TALLAWONG STATION **PRECINCT SOUTH**

ADDENDUM URBAN DESIGN REPORT

Rev. F_20.01.2021

AMENDMENTS TO BUILDING ENVELOPES FOOTPRINT & STOREYS

STREET NETWORK AND HIERARCHY

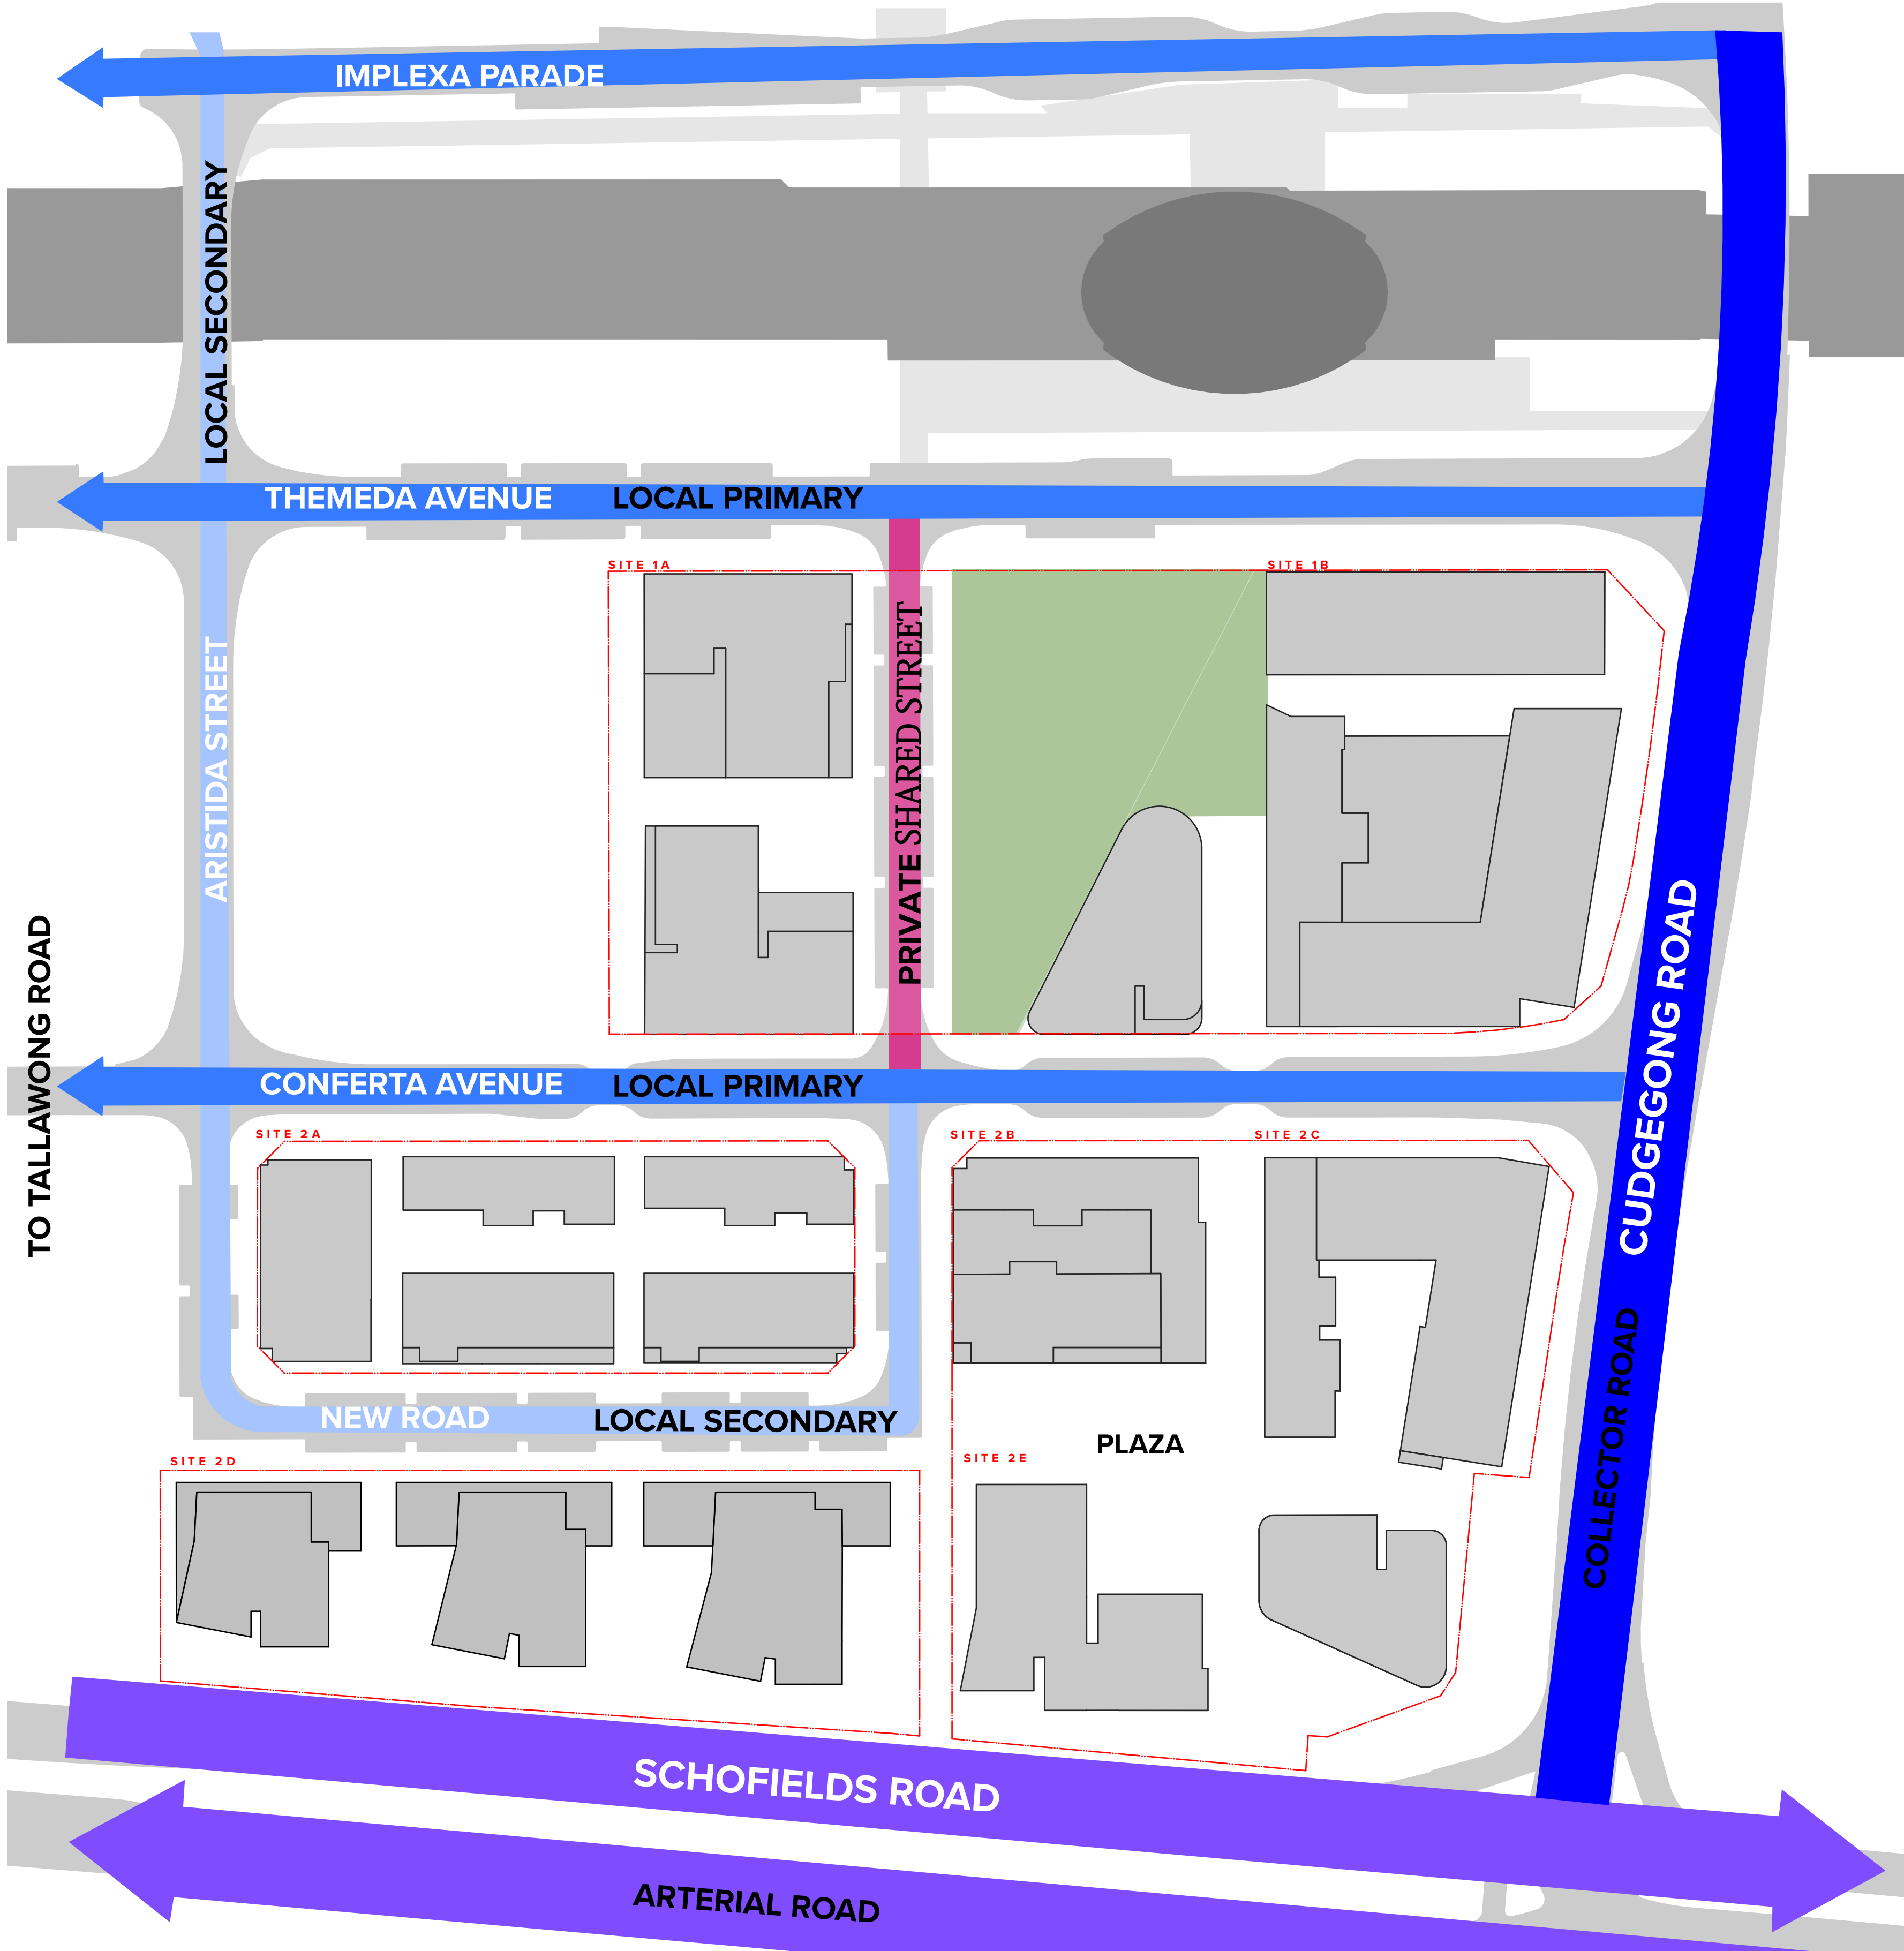
The Approved SSDA Scheme identifies a new north-south road in Site 1 to the west of the park, which connects Themeda Avenue with Conferta Avenue, which was intended to be constructed and dedicated to Blacktown City Council.

However, after discussions with Council, it is proposed that this road will be retained in private ownership with public access of the road secured on title.

This affords the opportunity to redesign the road to better integrate with the park and public domain, while reinforcing a pedestrian priority.
